[Docket No. FAA-2017-0640; Directorate Identifier 2017-CE-020-AD; Amendment 39-18969; AD 2017-15-09]

Airworthiness Directives; Diamond Aircraft Industries GmbH Airplanes

2017-15-09 Diamond Aircraft Industries GmbH: Amendment 39-18969; Docket No. FAA-2017-0640; Directorate Identifier 2017-CE-020-AD.

Figure 1 to paragraph (f)(1)(ii) of this AD:
Sequence of Actions for Exhaust Clamp Installation of
DAI Work Instruction WI-MSB 42-120, Revision 3, dated July 6, 2017

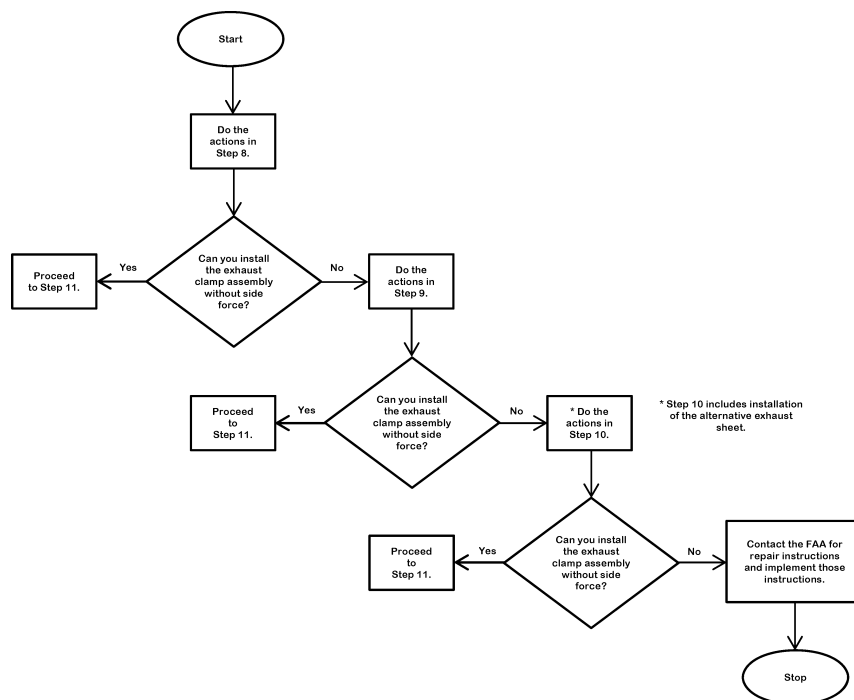
(ii) Reinstall any uncracked clamp or replace with a new clamp and incorporate spring washers following III.2 Action 2—installation of additional exhaust clamp in the INSTRUCTIONS section of DAI Work Instruction WI-MSB 42-120, Revision 3, dated July 6, 2017, as specified in DAI Mandatory Service Bulletin MSB 42-120/2, dated June 7, 2017. See figure 1 to paragraph

(f)(1)(ii) of this AD for additional information on the sequence of installation actions as identified in DAI Work Instruction WI-MSB 42-120, Revision 3, dated July 6, 2017. Credit is not given for installation of an engine exhaust clamp installed following DAI Work Instruction WI-MSB 42-120, Revision 1, dated December 14, 2016, (installation of exhaust clamp without spring washers), or DAI Work Instruction MSB-42-120, Revision 2, dated June 7, 2017.
